**Re: Lot 15 Block 5 Volcano Cliffs Subd. SAD 228  
6636 Sujeto Rd NW  
Grading & Drainage Plan  
Engineer's Stamp dated: 4-28-19 (D10D003K15)**

Based upon the information provided in your submittal received 5/8/2019, this plan is approved for Grading Permit.

Lots 15, Block 5, Volcano Cliffs Subdivision, Unit 18  
6636 Sujeto Road, NW  
GRADING PLAN

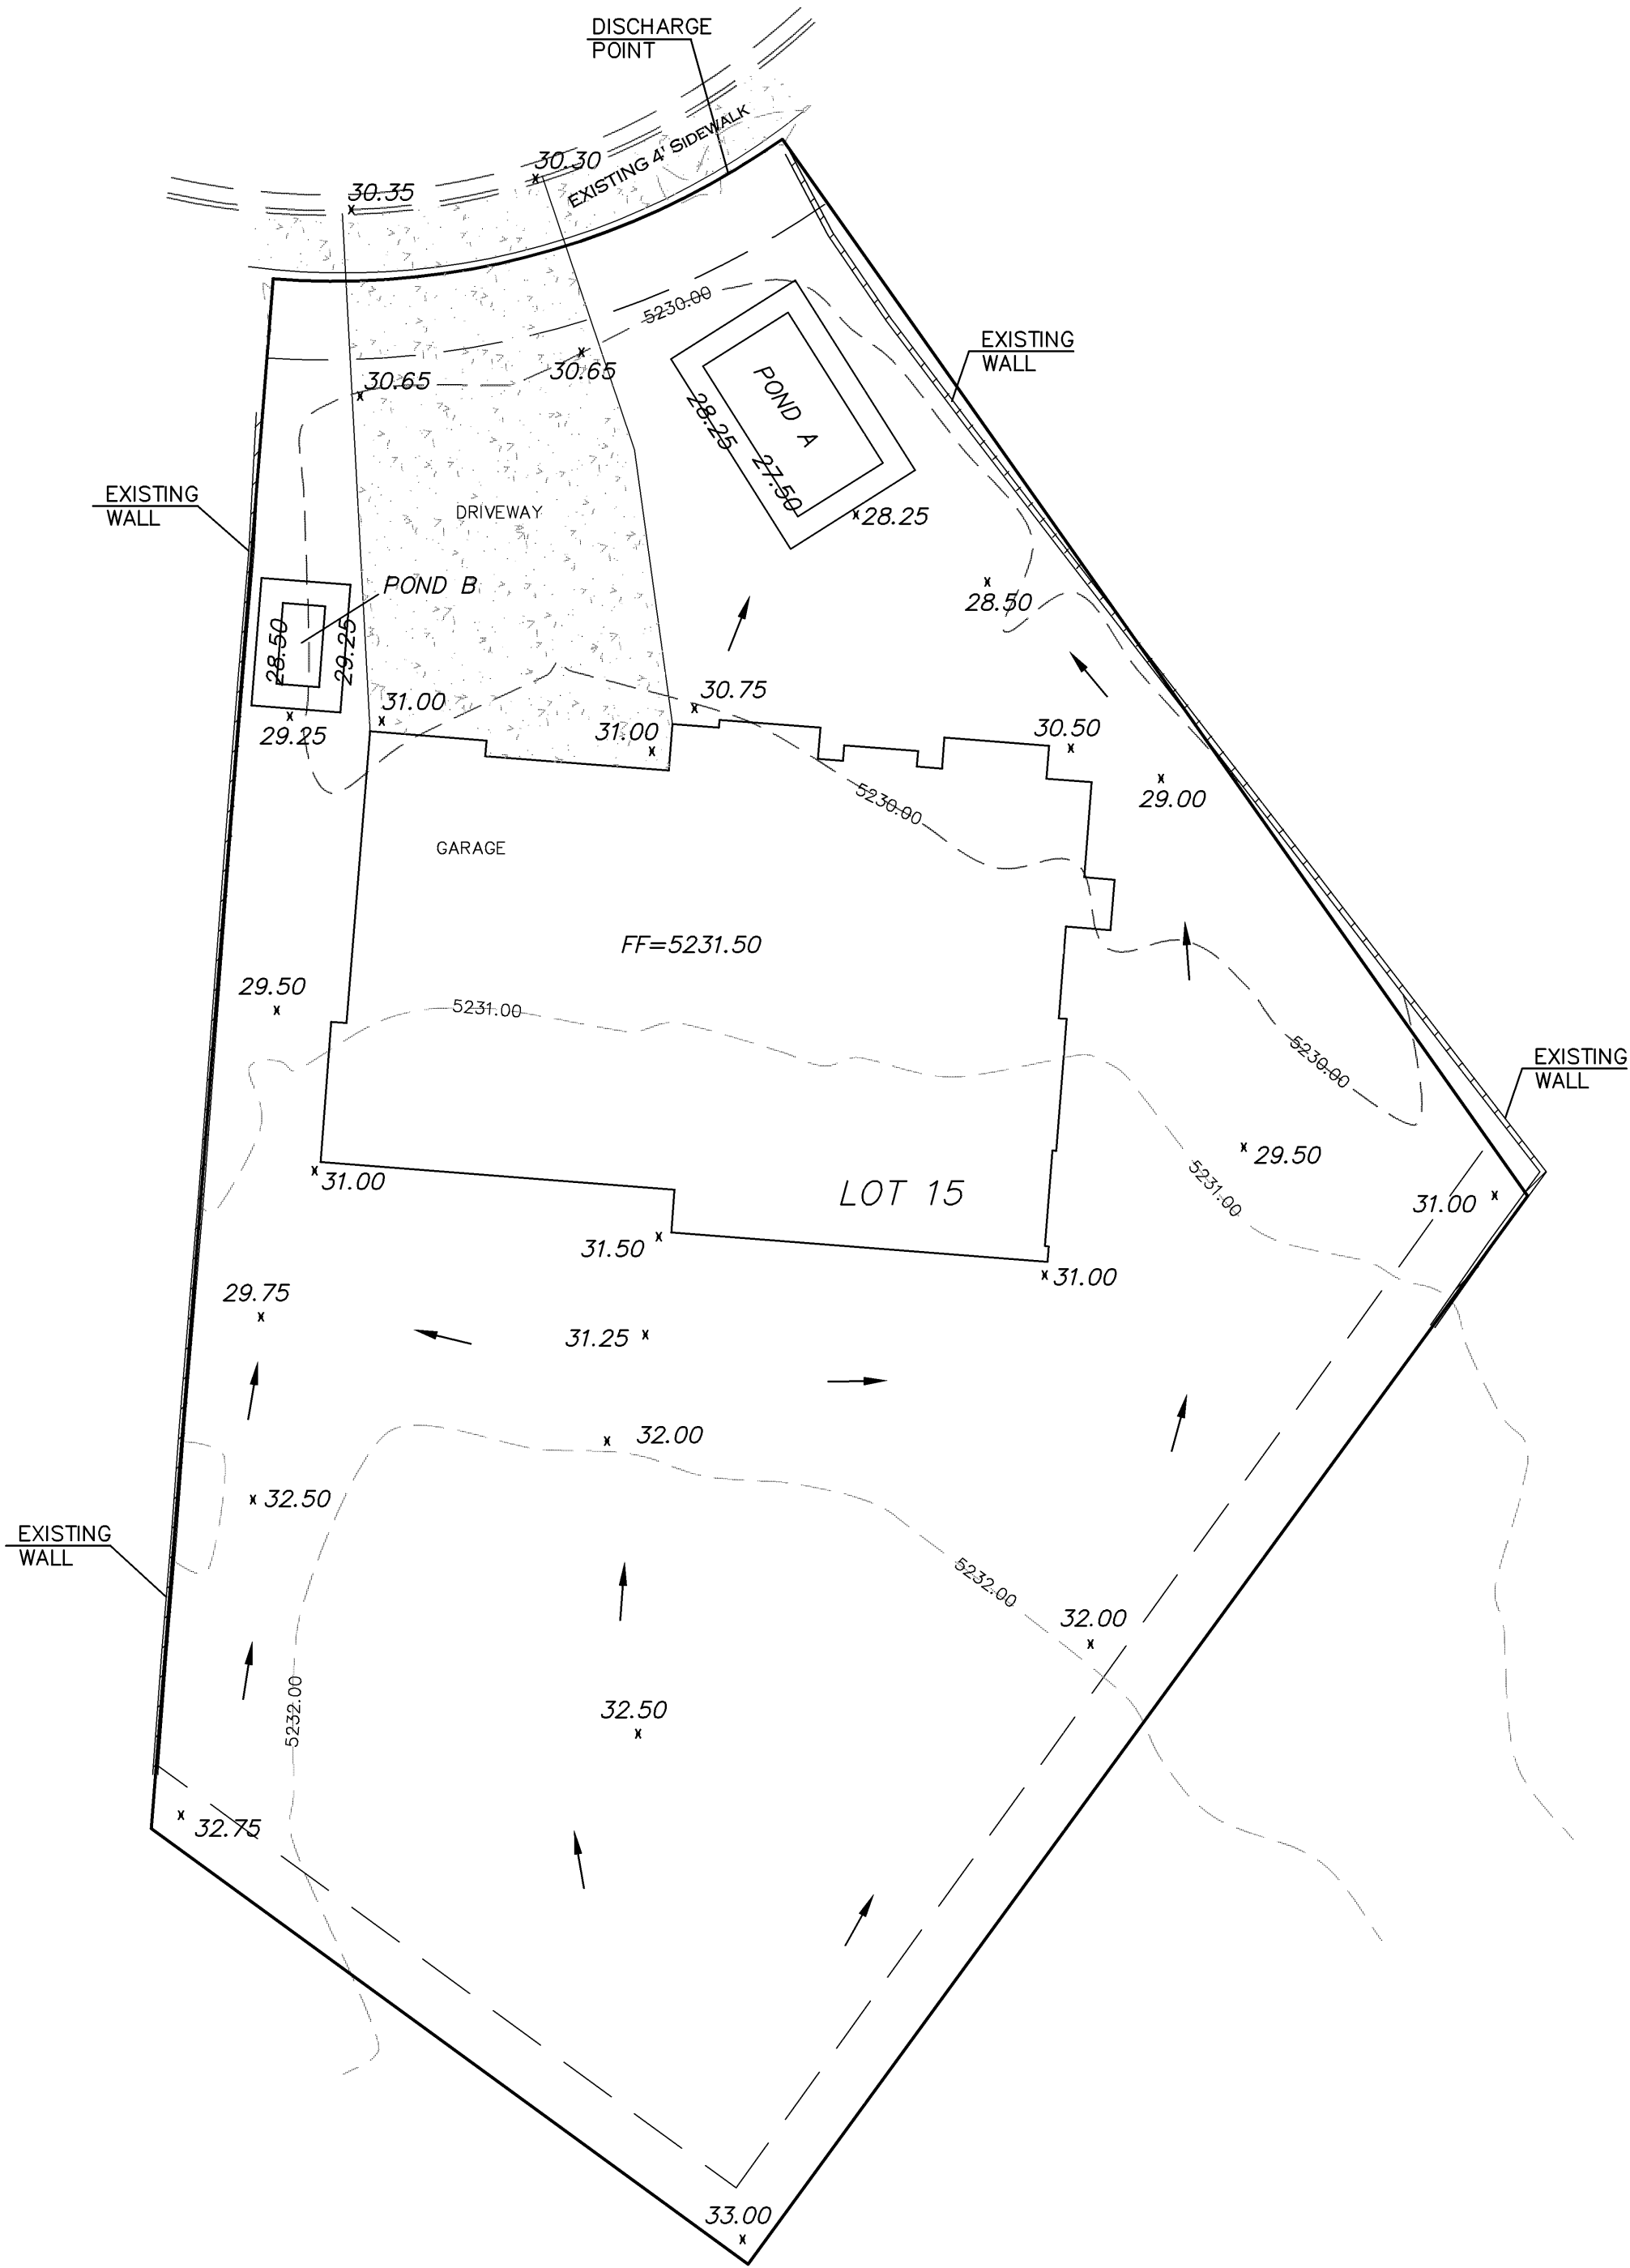
**Prior to Building permit approval a Pad Certification will be required, provided by the Engineer or a registered Land Surveyor. Also, provide a note on the plans stating that a separate permit is required for a garden wall/retaining wall.**
